MAHONING ROAD NE
 STA-0153-01.70

INTERSECTION DETAILS
GRACE AVENUE NE / INIANA AVENUE NE

REVISIONS	DATE	BY
CONSTRUCTION BIDDING SET	4/21/14	GEA
ADDENDUM NO. 1	5/7/14	GEA
STM SWR REVISIONS	10/1/14	GEA

STREETSCAPE PLAN
STA. 89+50 TO STA. 95+50

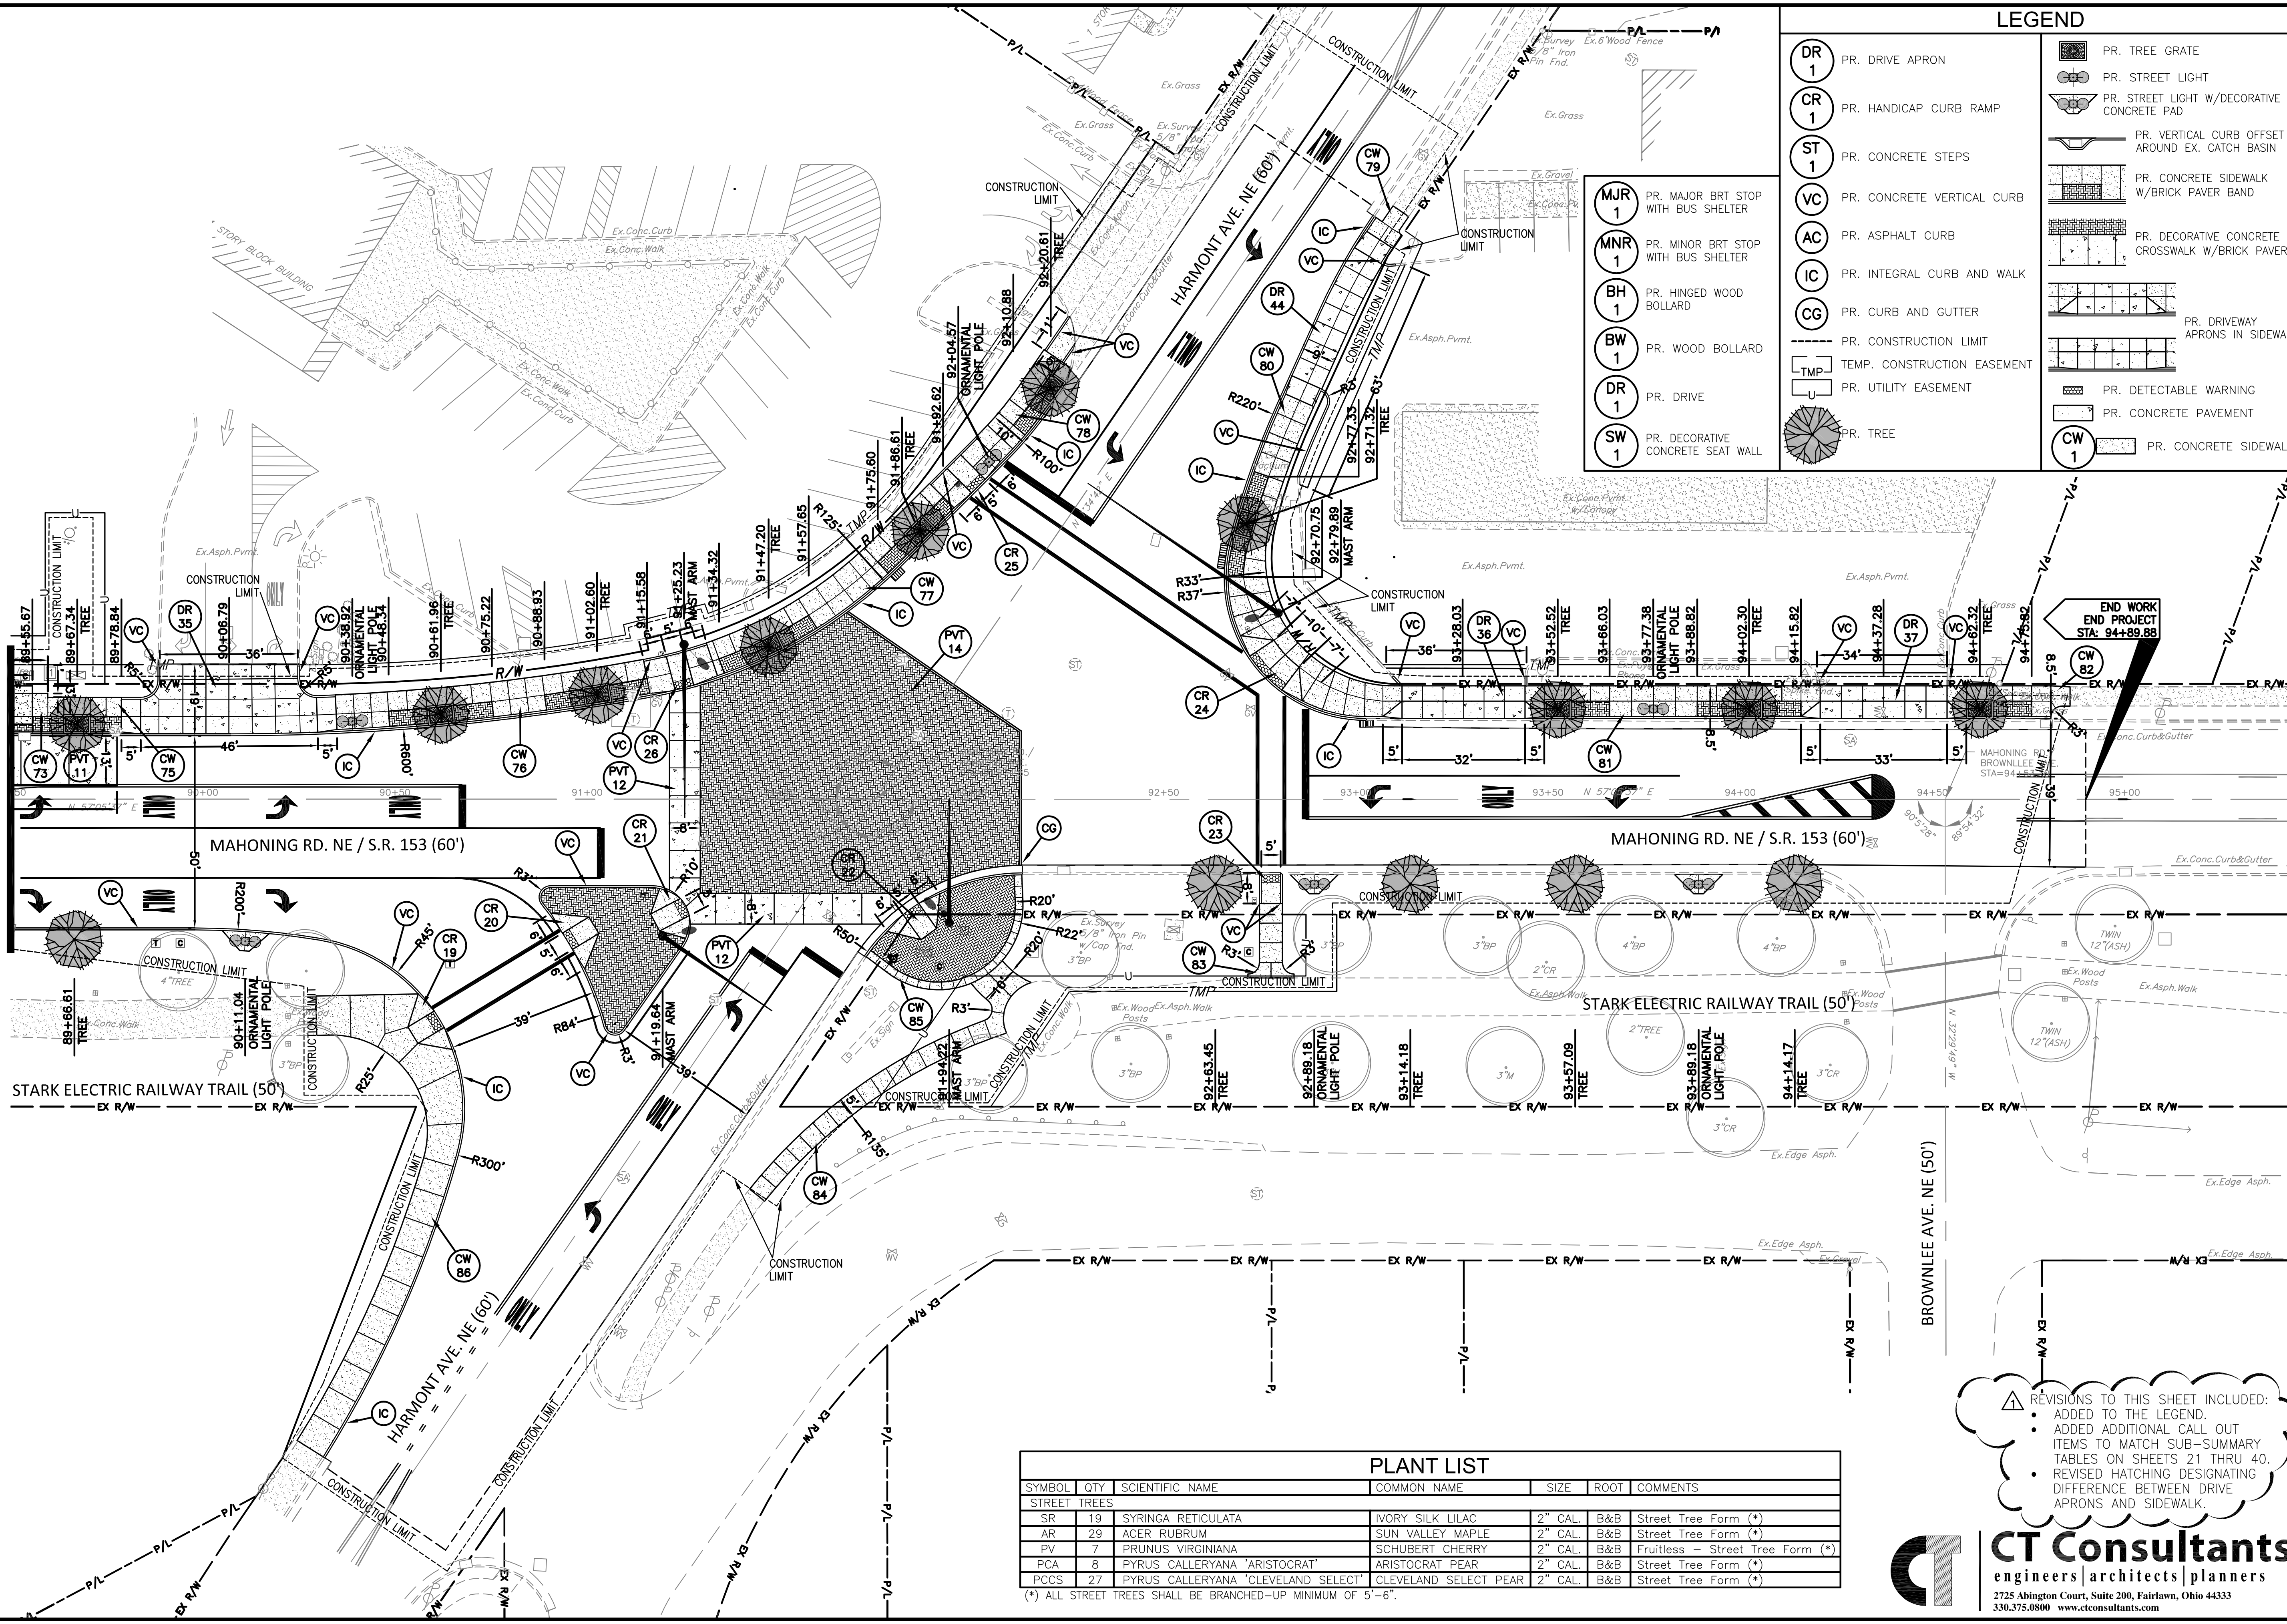
REVISIONS TO THIS SHEET INCLUDED:
 • ADDED TO THE LEGEND.
 • ADDED ADDITIONAL CALL OUT ITEMS TO MATCH SUB-SUMMARY TABLES ON SHEETS 21 THRU 40.
 • REVISED HATCHING DESIGNATING DIFFERENCE BETWEEN DRIVE APRONS AND SIDEWALK.

PR. SIGNAGE & PAVEMENT MARKING PLAN
STA. 66+50 TO STA. 78+00

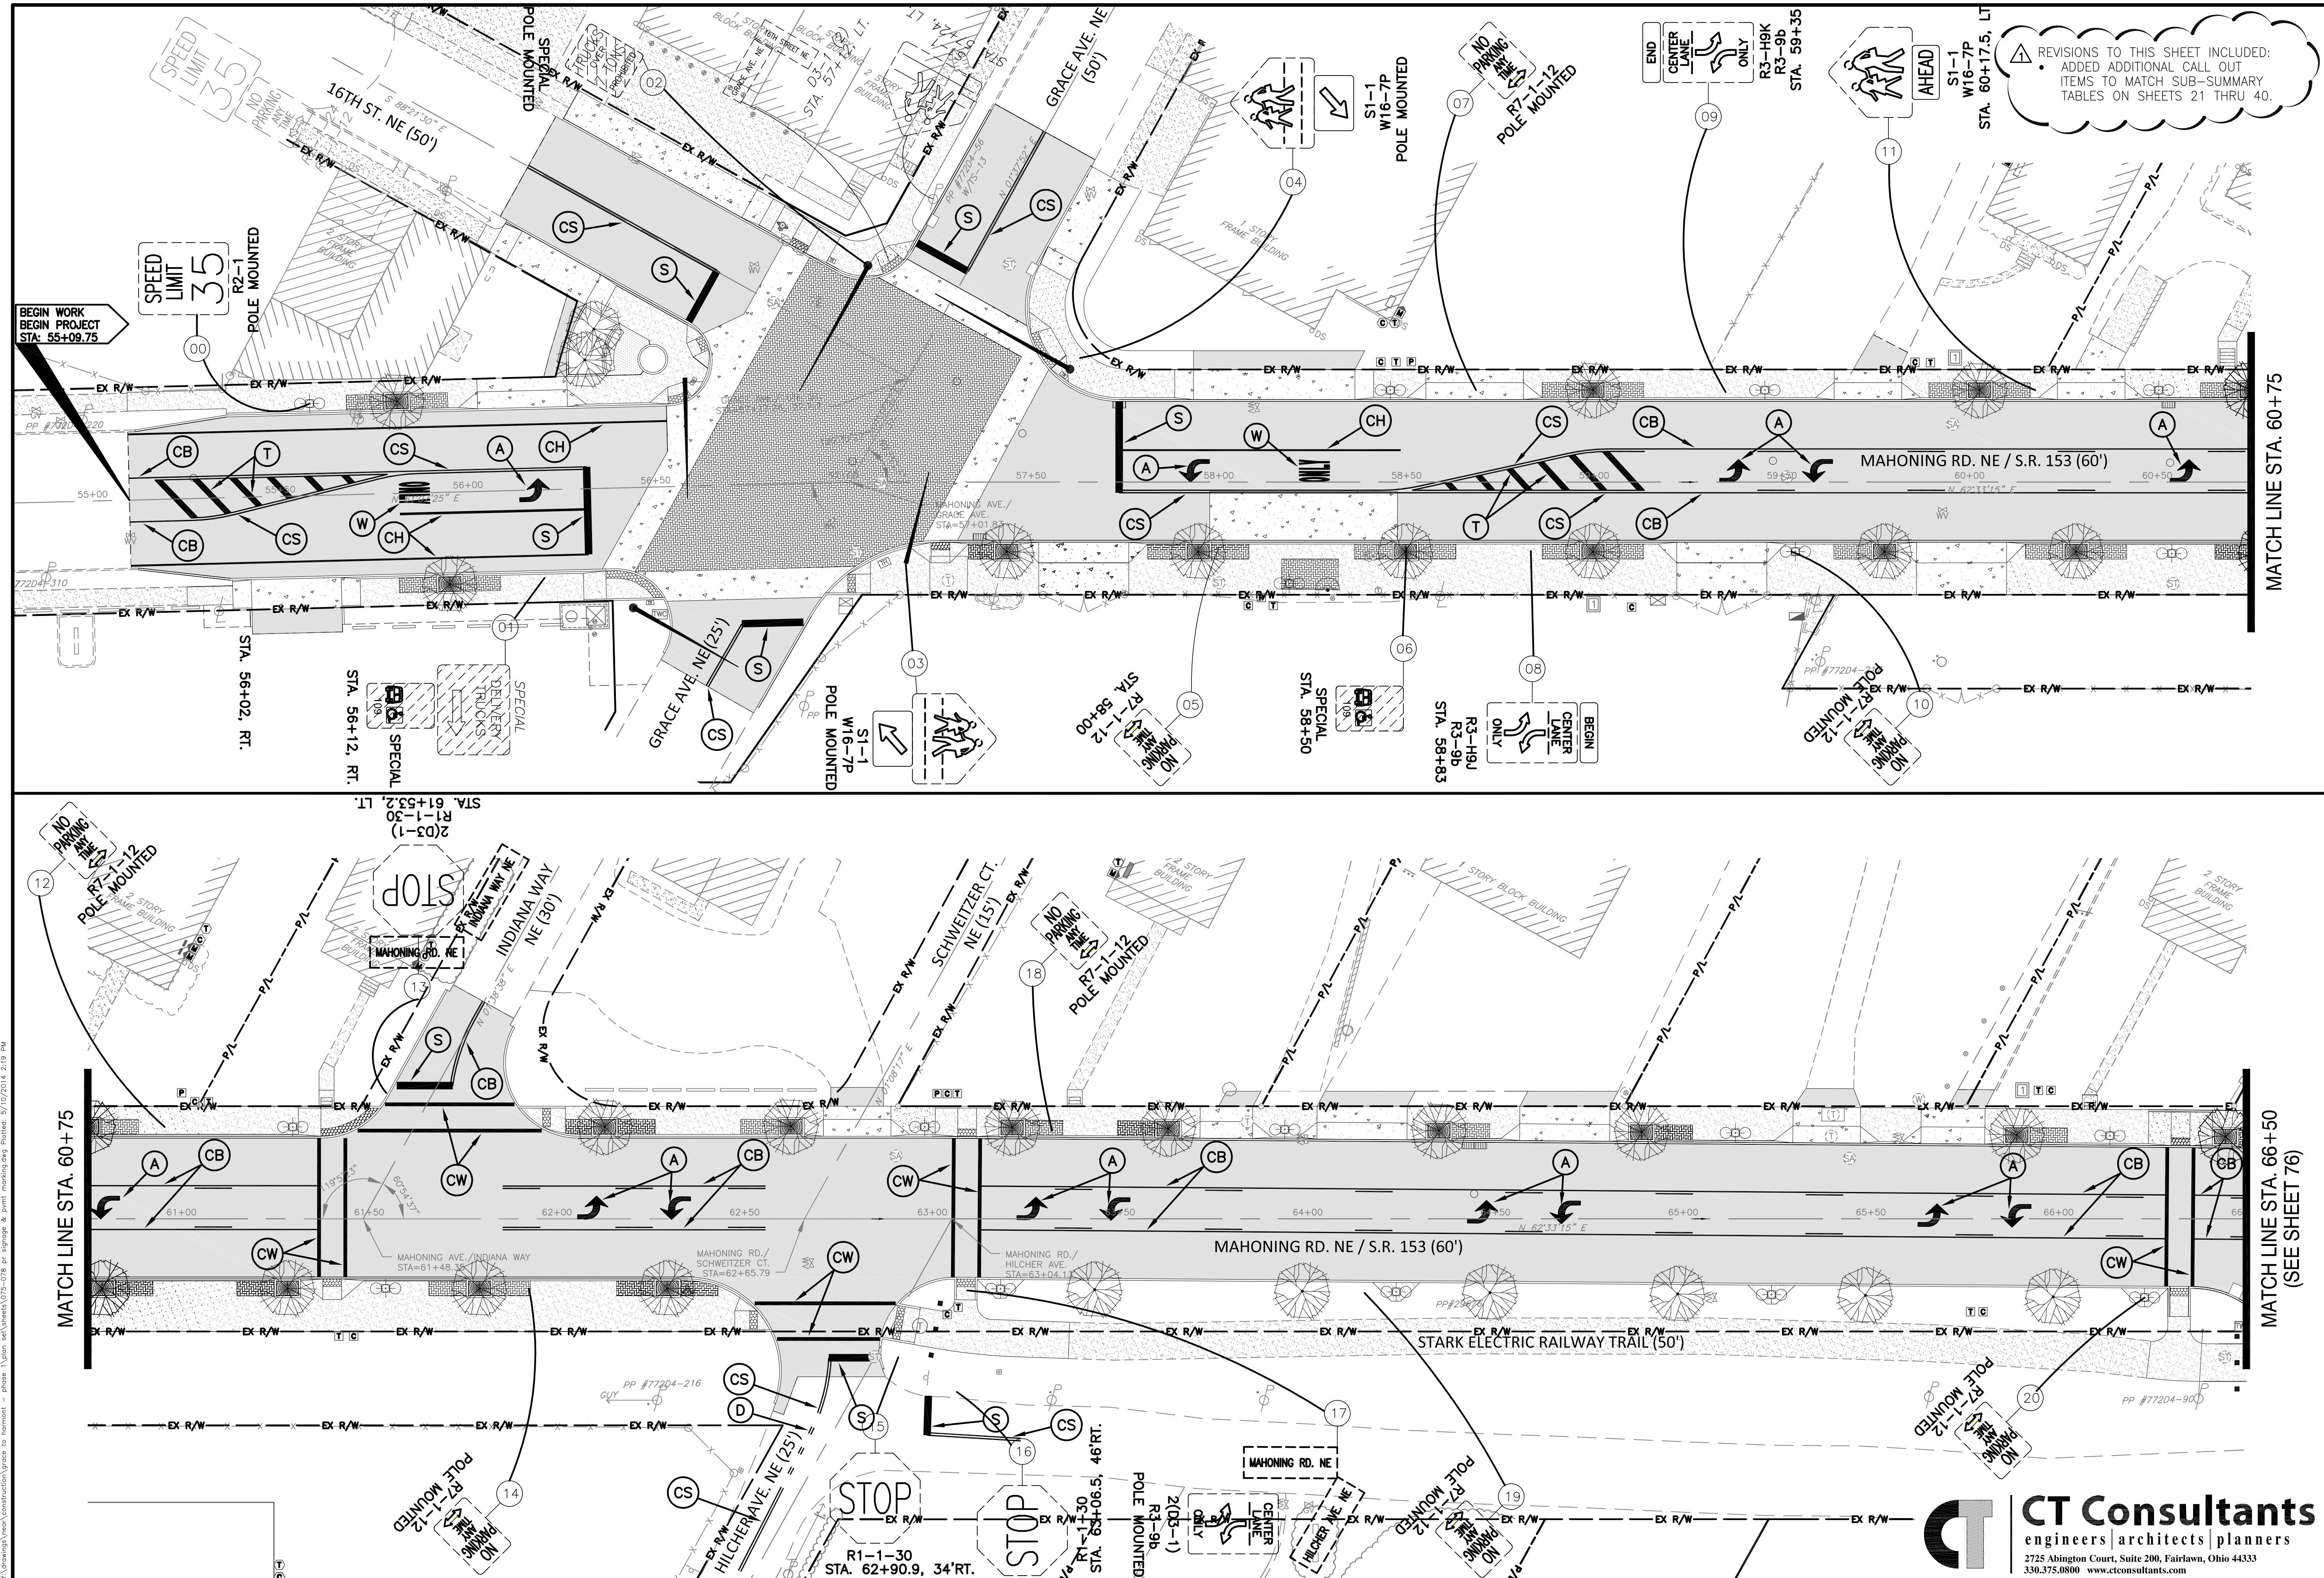
REVISIONS TO THIS SHEET INCLUDED:
• ADDED ADDITIONAL CALL OUT ITEMS TO MATCH SUB-SUMMARY TABLES ON SHEETS 21 THRU 40.

PR. SIGNAGE & PAVEMENT MARKING PLAN STA. 66+50 TO STA. 78+00	CALCULATED: GEA CHECKED: JGC
	DATE: 4/21/14 BY: GEA
REVISIONS: CONSTRUCTION BIDDING SET APPENDUM NO. 1	5/7/14 GEA
MAHONING ROAD NE STA. 0153-01.70	76 108

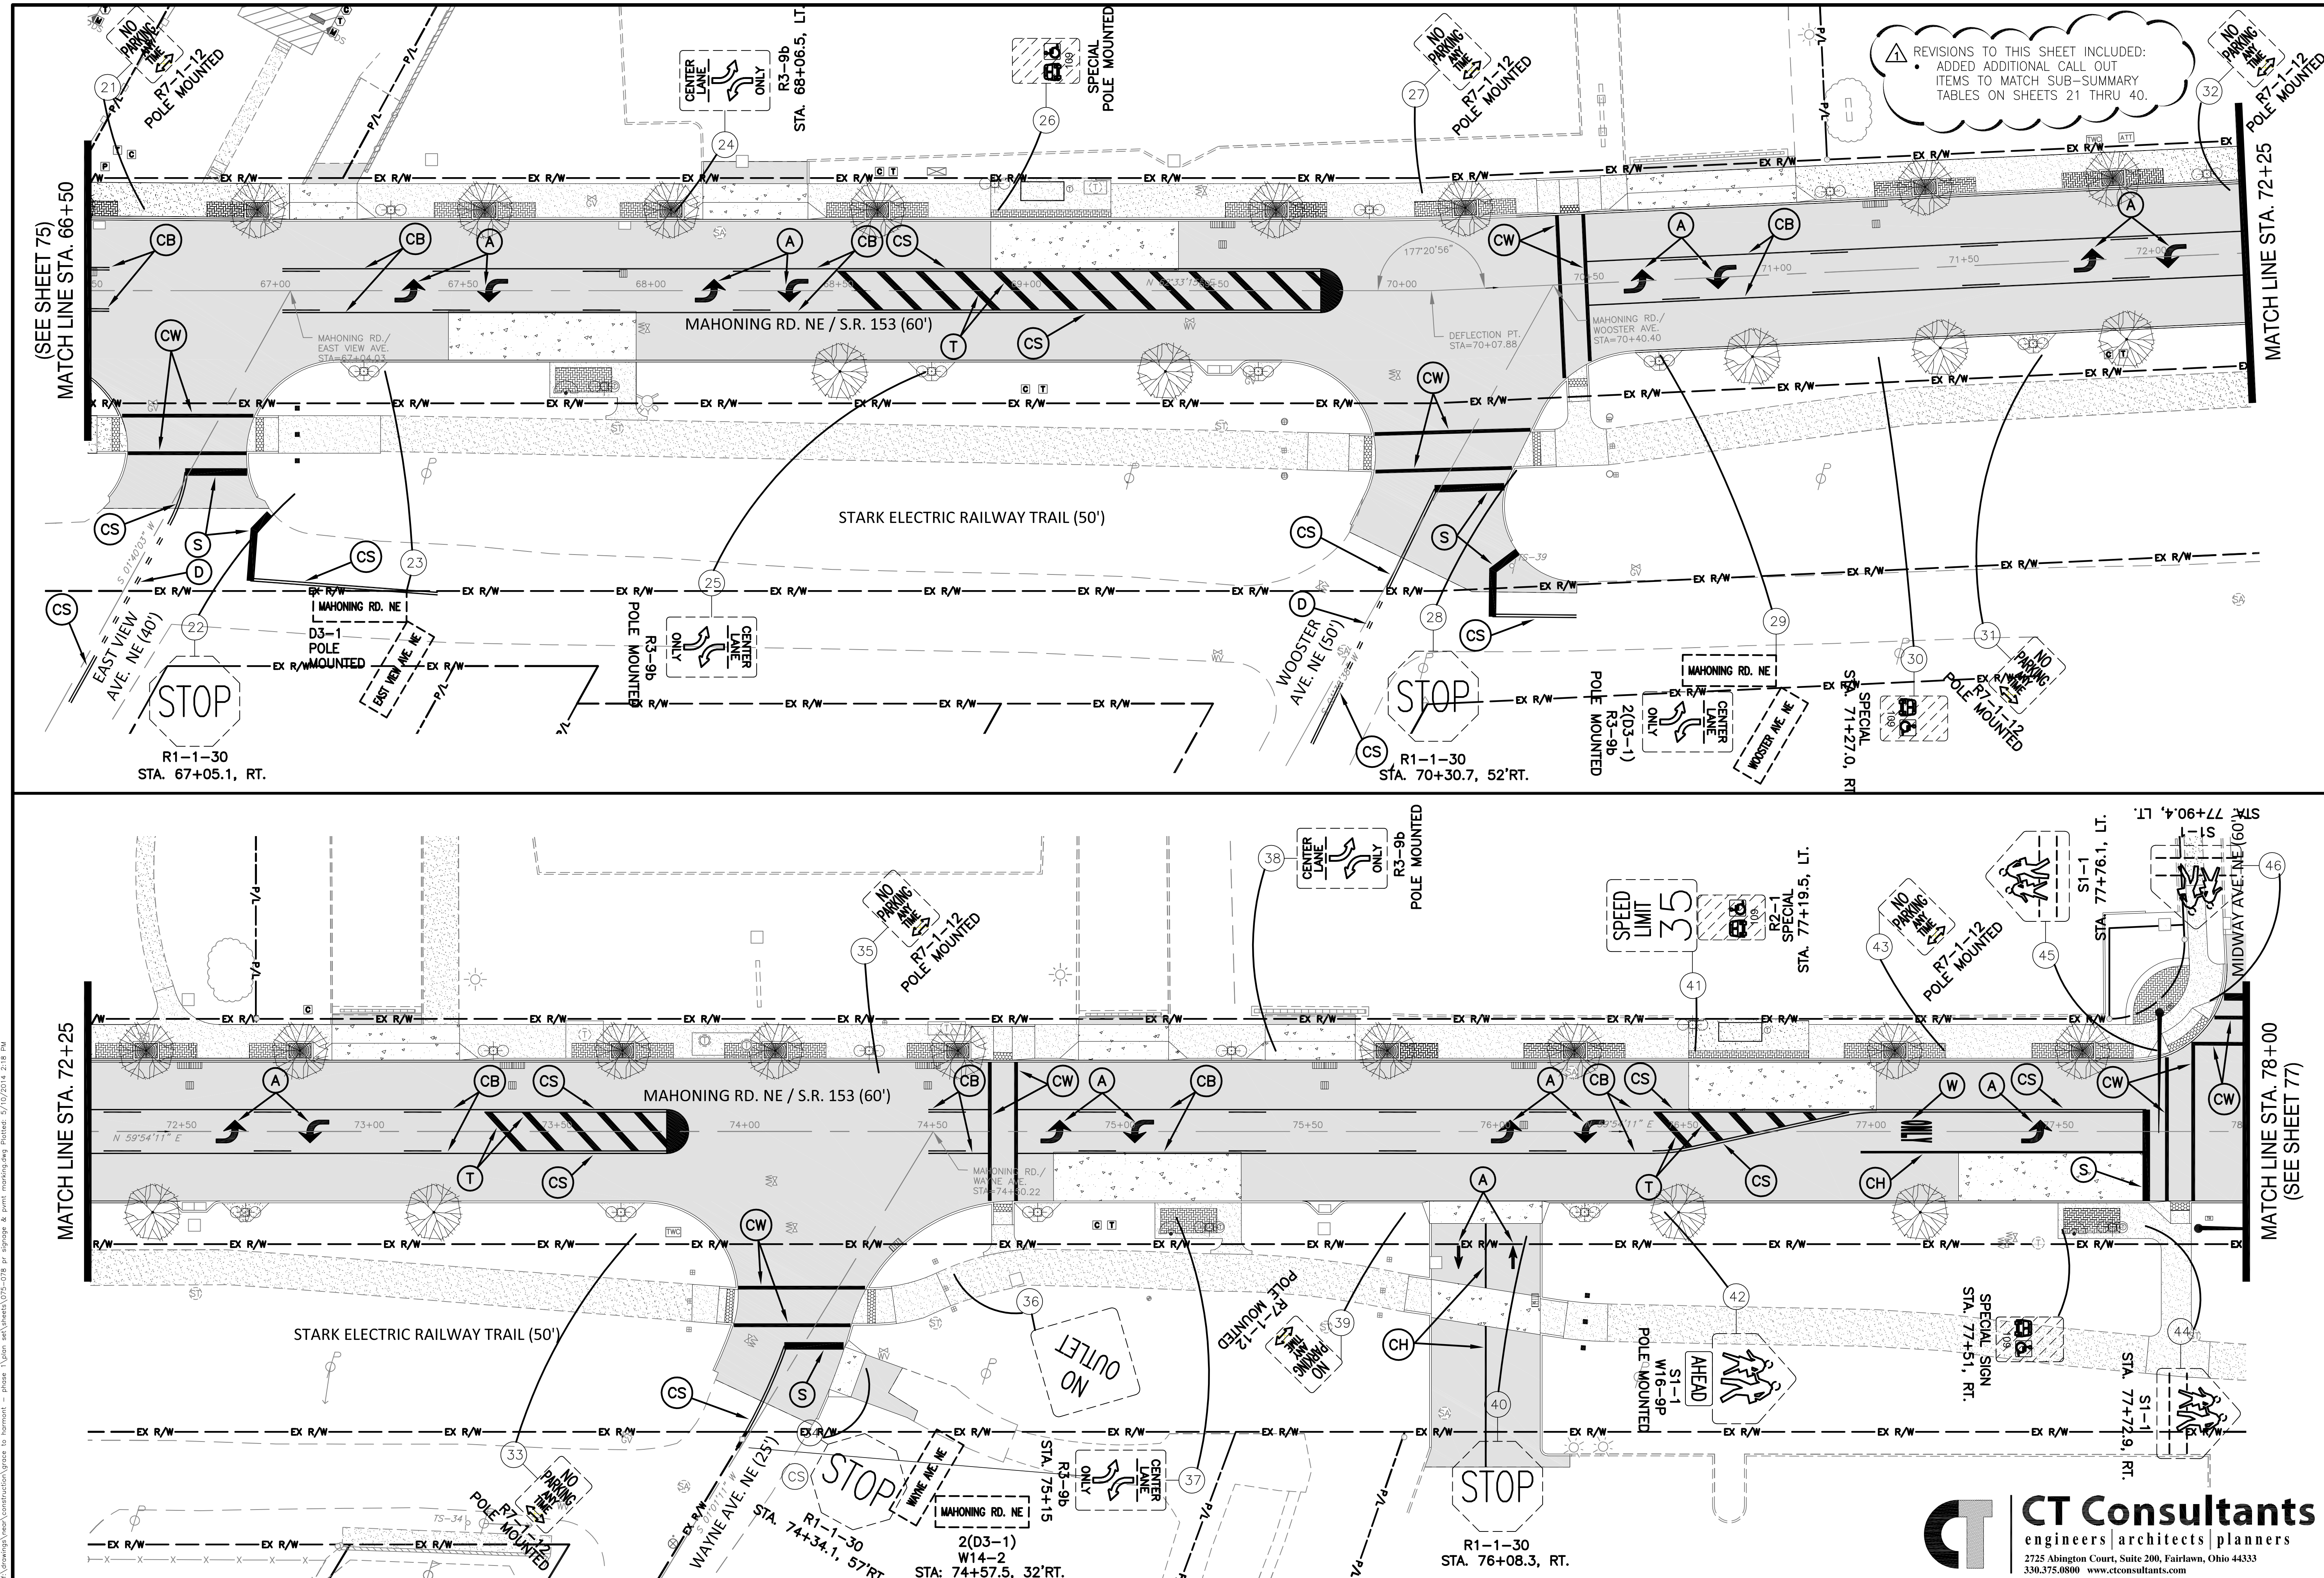
REVISIONS TO THIS SHEET INCLUDED:
ADDED ADDITIONAL CALL OUT
ITEMS TO MATCH SUB-SUMMARY
TABLES ON SHEETS 21 THRU 40.
